Submission to the Independent Planning Commission

Objection to SSD-47105958 – Uniting Kingscliff Redevelopment

Subject: Objection to SSD-47105958 – Uniting Kingscliff Redevelopment

Date: 1st November 2025

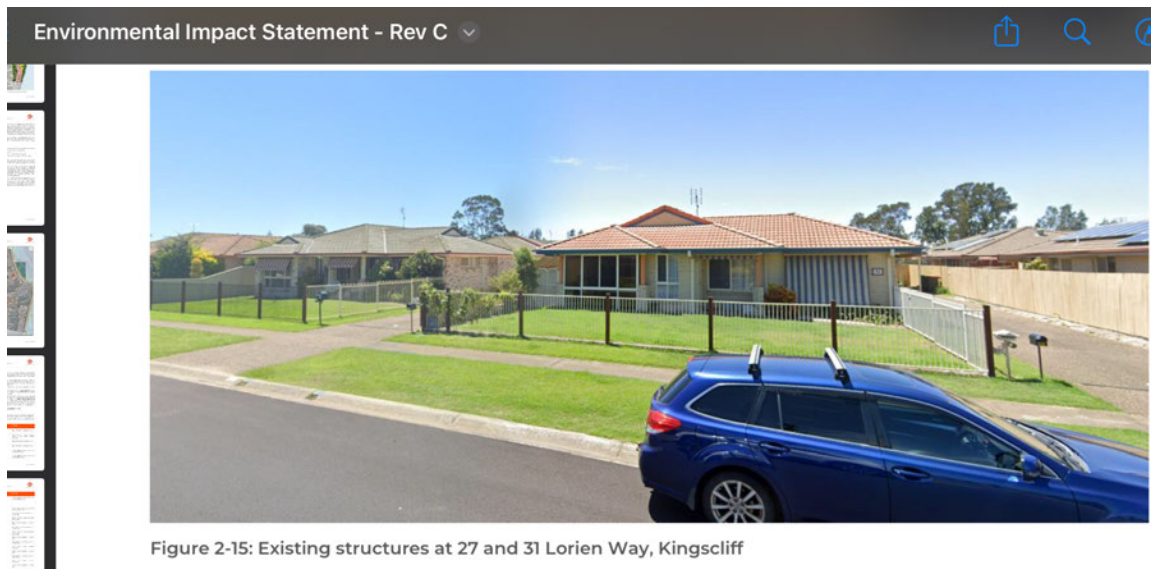
This claim is incorrect. The surrounding area consists almost entirely of 1- and 2-storey dwellings. The proposed 4-storey central blocks—combined with large roof forms, elevated pad levels, and minimal setbacks—would dominate all adjoining properties.

How can going from one storey to four stories (building B east of 37 & 41 Lorien Way) over a distance less than the width of a volley ball court (9m) be deemed an appropriate transition? One that is not even addressed in Drawing 03 Urban Structure & Identity Site Structure.

At the time this picture was taken the tallest tree on the right was measured at 12m it sits in the bottom of the detention basin and is approximately 20 metres from the rear of 37 and 41 Lorien Way. Building B will be 17.05m high with only a 9m setback i.e. 11 m closer.

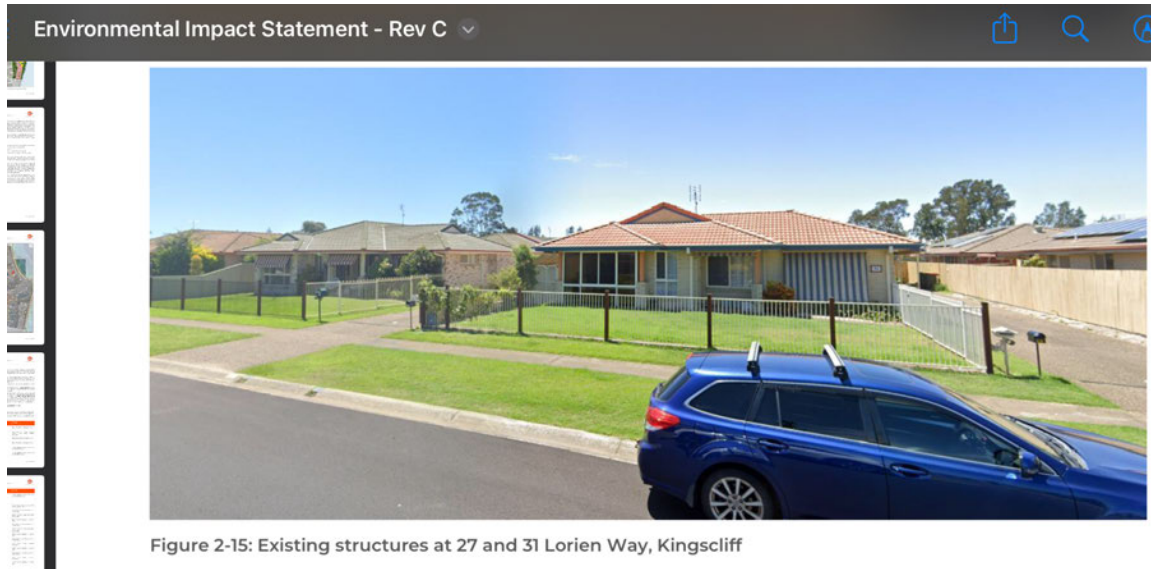
This is a picture taken from our dinning room (kitchen and living room have same aspect) Building A will be 1m further back from the nearest wall on the left but closer than the garage on the right. Being a two storey building you can see that we will **lose sight of the sky**, will be severely overshadowed, private spaces (both internal and external) overlooked, and with **living rooms directly opposite ours**, everyday noise—TVs, radios, conversation—will carry straight across.

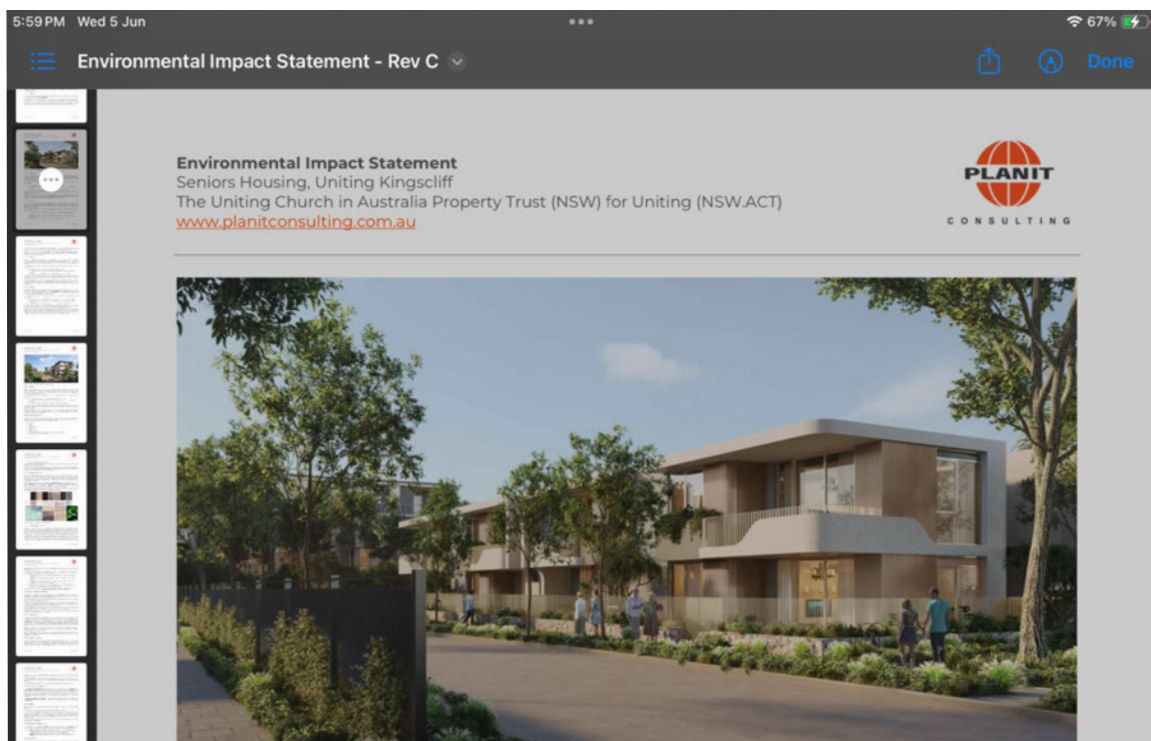
How can anyone say the proposed building below fits in with the existing surroundings as above? NB disingenuously the drawing below only shows half of Building A?
